Report to the Future Melbourne (Planning) Committee

**Planning Permit Application: TP-2018-790
45 and 47 Arnold Street, South Yarra**

12 November 2019

DELEGATE REPORT

Extract of Proposed Ground Floor Plan

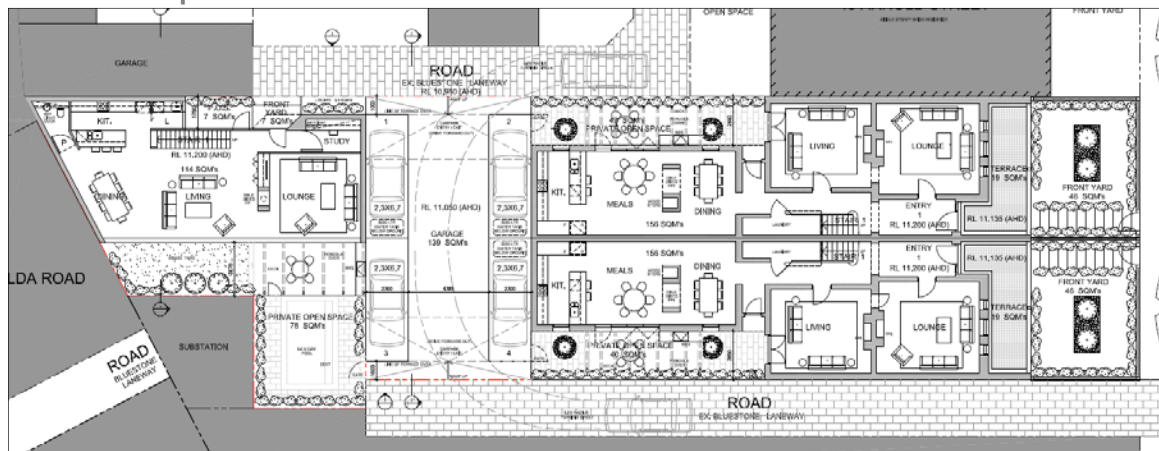
The development includes construction of first floor terraces to the rear of the existing dwellings, pergolas above the courtyards and terraces, and part demolition of the side and rear elevations associated with alterations to the fenestration as discussed in section 9.2 of this report.

While the Heritage Advisor recommended that the first floor terraces be setback from the north and south boundaries to align with the sides of the existing dwellings, the first floor terraces are considered acceptable as proposed because:

- They will not be visible from Arnold Street or Bromby Street. They will only be visible from the adjoining laneways, which are no through roads and do not have a streetscape grading.
- They enclose the carpark and align with the entry and exit gates at ground floor level.
- They do not detract from the prominence of the existing dwellings given their lightweight, permeable design.
- The front portion of the existing dwellings is built to the side boundaries, the rear portion is setback 2.7m and the first floor terraces will be setback 1m, providing an appropriate design response.

Extract of Proposed South Elevation

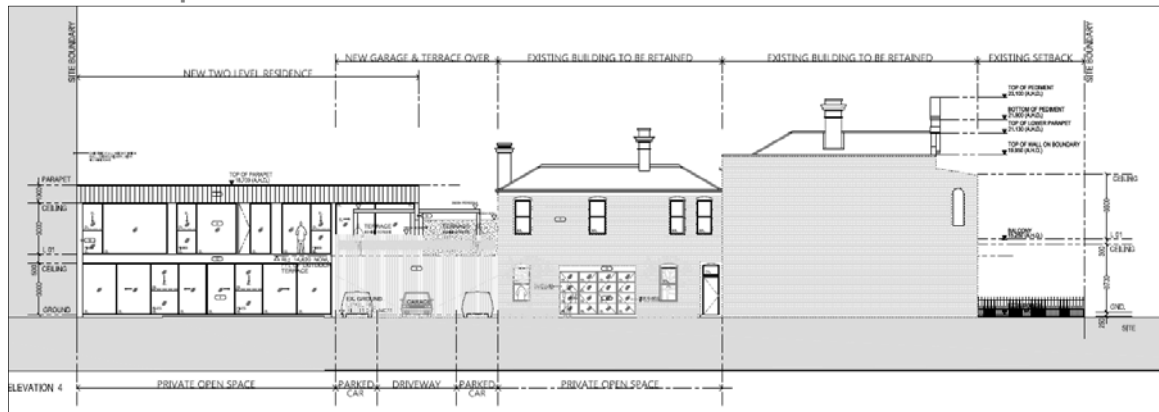
The scale and design of the new dwelling responds to the features of the site and surrounds. It sits comfortably at the rear of the existing dwellings and will not be visible from Arnold Street or Bromby Street. It is lower than the existing dwellings and appropriately setback from the rear of the existing dwellings. It will not have an unreasonable impact on the amenity or equitable development of the adjoining properties having regard to the surrounding built form. It has a contemporary form and appearance that does not dominate or detract from the heritage significance of the existing dwellings. It is appropriately articulated by window openings and a complementary palette of materials and finishes. It includes 10.5m² and 78m² of garden area on the north and south sides of the building respectively, to contribute to the landscape qualities of the area.
